SUNDRY NOTICES AND REPORTS ON WELLS
Do not use this form for proposals to drill or to re-enter an abandoned well. Use form 3160-3 (APD) for such proposals.

BP America respectfully request permission to perform bradenhead repair on the subject well as per the attached procedure.

Riddle C LS 2
API #: 30-045-10372
T31N R9W Sec30

Conditions of Approval:

Riddle C LS 2

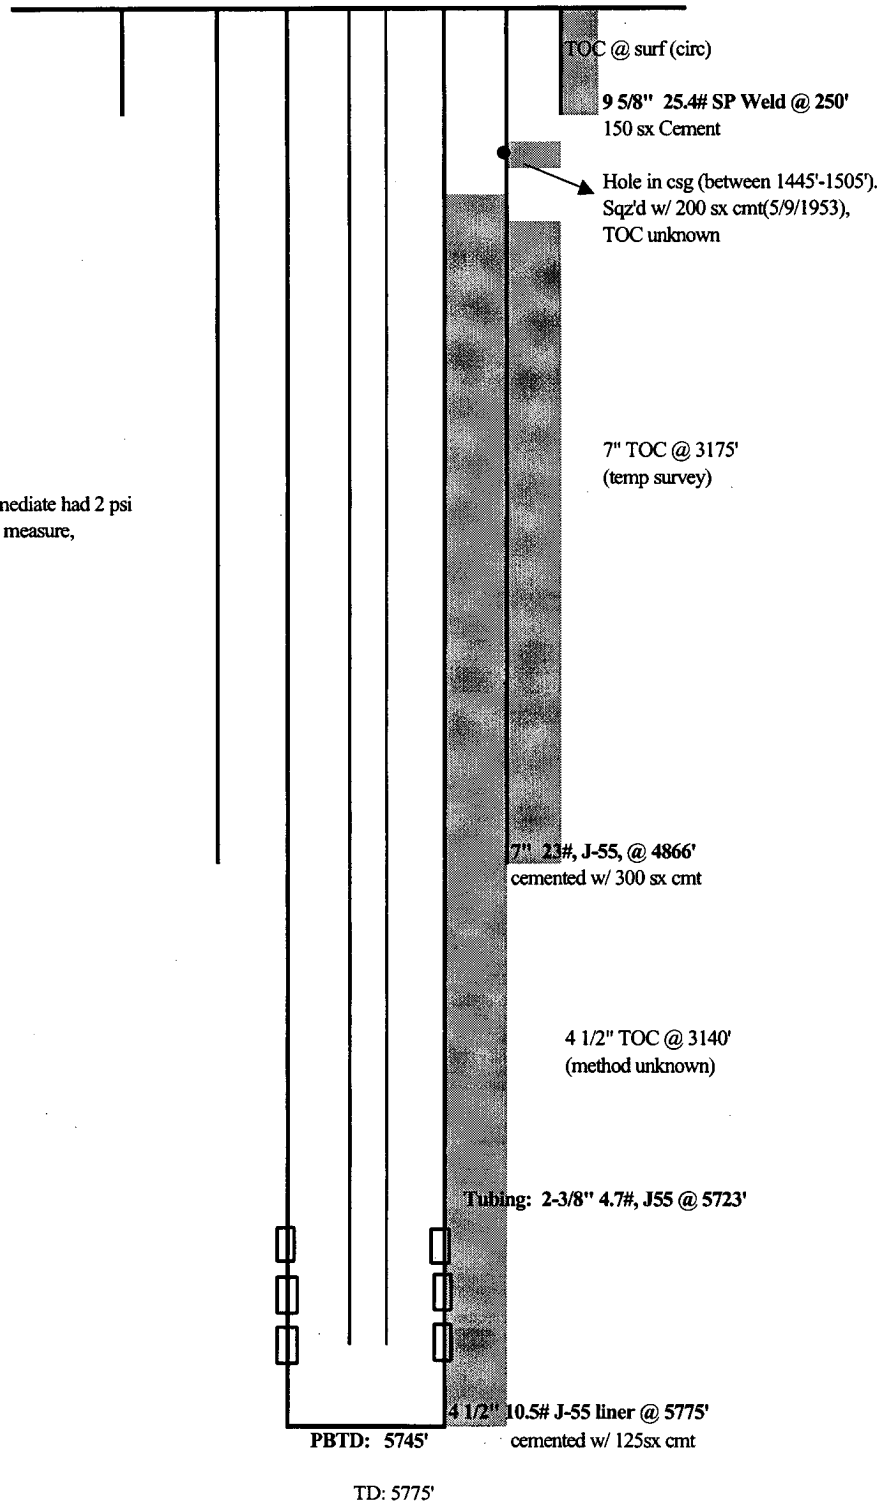
- 1) Notify Farmington Field Office if remedial cement work is warranted.
- 2) Contact Matt Halbert, 505-599-6350, when CBL's are going to be ran for 4 ½ and 7" casing.
- 3) Keep BLM updated on your progress and if additional work is warranted.
